# **TECHNICAL SERVICE BULLETIN 10043**

**MODEL(S):** 150GTL, 200GTL

**DESCRIPTION:** Receiver overloads when receiving a strong signal, resulting in distorted audio. In addition there may be a warble in the modulation when transmitting (which might be described as a popping sound during transmit).

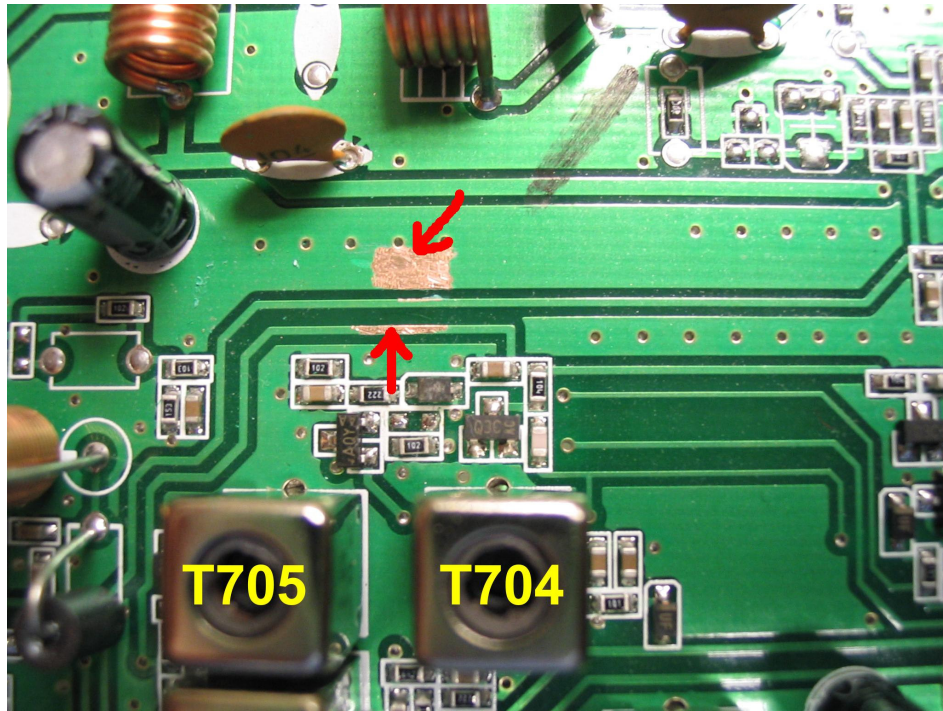
**ACTION:** RF is bleeding into the receiver front-end. Apply the following fix:

For both the 150GTL and 200GTL, install a 1 $\mu$ F electrolytic capacitor across C607. (From C607 to ground)

1 $\mu$ F electrolytic capacitor: Cobra part number 020-007
